URBAN DESIGN CONSULTATION RESPONSE

Design Officer	Azhar Kapadi
Date	12.02.26
Application Reference	PL/2025/1221
Address	Land off Hareshill Road North, South Heywood, Rochdale
Proposal	Reserved matters application for access, layout, scale, appearance and landscaping for 186 residential dwellings and associated works pursuant to hybrid planning permission 16/01399/HYBR

H Elevation/Section C-C, 1:200

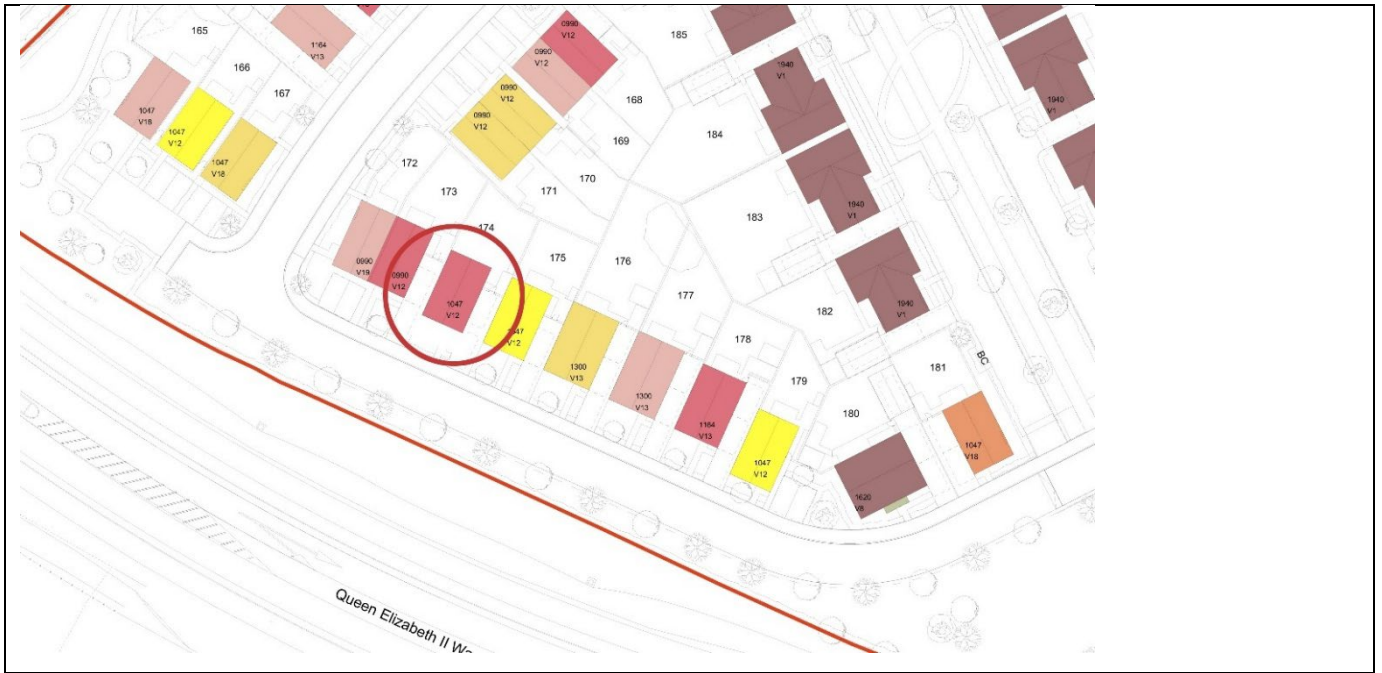
For Sections CC and DD, the larger housetypes and better-quality brick make the mixed colour approach work, and the housetype-brick pairings (e.g. 1940 V1 with Red Brick 3, 1620 V6 with Buff Brick 3) read consistently.

In Section EE, the lack of a stronger brick choice makes the colour mix feel scattered, and although the frontages themselves are well designed, the colour arrangement seems disjointed.

Adopted highway and cycleway route

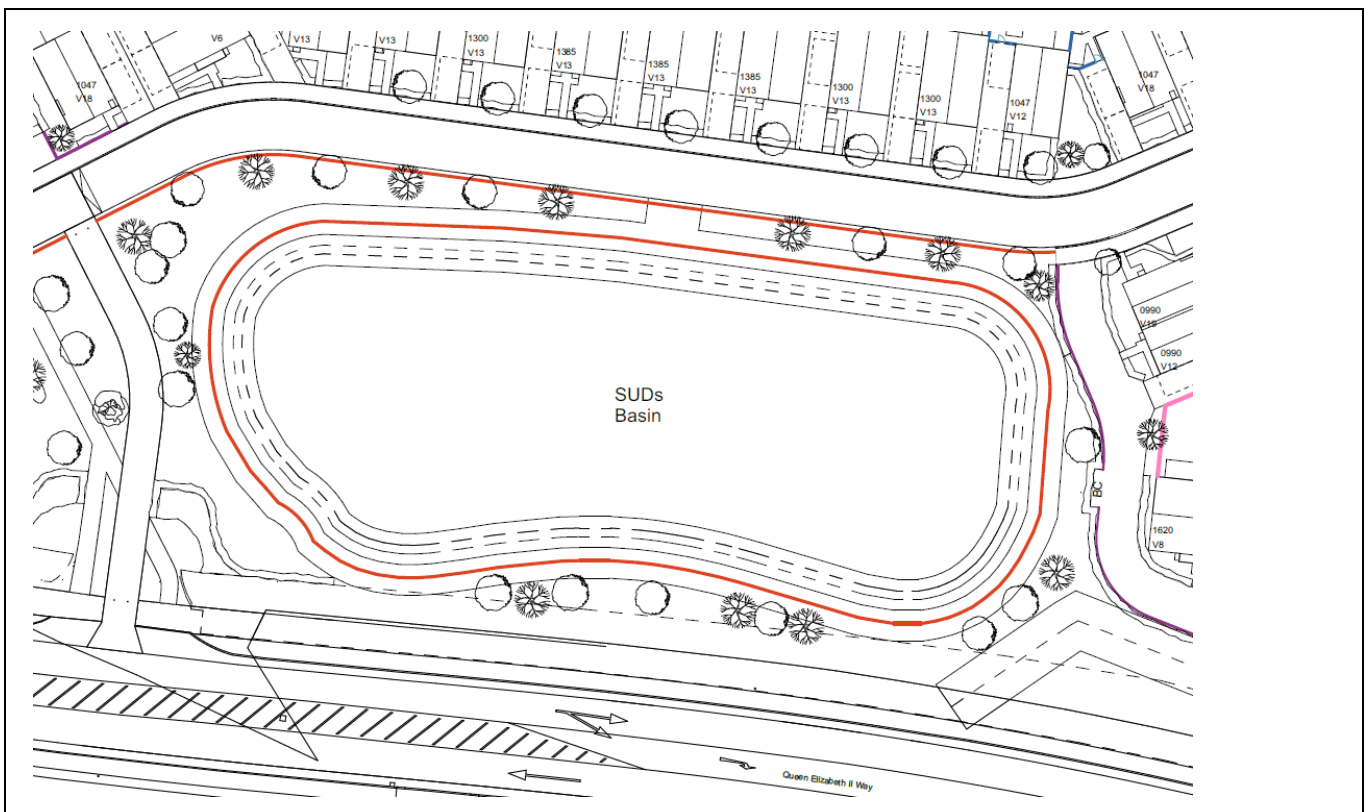
A more detailed section is required through the highway and cycle path to clearly show kerb locations and the relationship to the adjoining houses, driveways and footpaths. It would be helpful to see two versions of this section: one taken through a driveway and one taken where no driveway is present. Although a section is provided on drawing SH01-P-SS-001, a closer-scale, more detailed section would be beneficial for this particular part of the layout.

With one side of the street lacking a footway, we need to understand how the thresholds between the carriageway, cycle path, landing strips and private driveways work. This will need further scrutiny with Highways, particularly in assessing whether a contrasting surface material for the cycleway is still appropriate without an accompanying footway. What is the strategy for crossover of adopted pavement meeting the cycleway? The sequence of tarmac road, dropped landing zone, cycle path and multiple driveway crossings must be reviewed to ensure safety is not compromised. This should be considered alongside the *Greater Manchester Streets for All Design Guide*.

This zone requires further testing, and there may be scope to adapt the current layout or review the cycleway width to determine whether a footpath could be incorporated. Crossing points also need to be more direct and safer; diagonal crossings should be avoided, and landing strips may need extending to achieve horizontal crossings.

While physical separation between the highway and cycle path has visual benefits, the user experience for cyclists with frequent level changes caused by numerous driveways needs to be acknowledged and assessed. This section will therefore require additional consultation / with Urban Design Team and Highways.

Can you confirm whether dropped kerbs will be shown in the Section 38 submission? Given the complexity of this interface, it may be worth including this detail at this stage for this specific area.

What is the lighting strategy to this area?
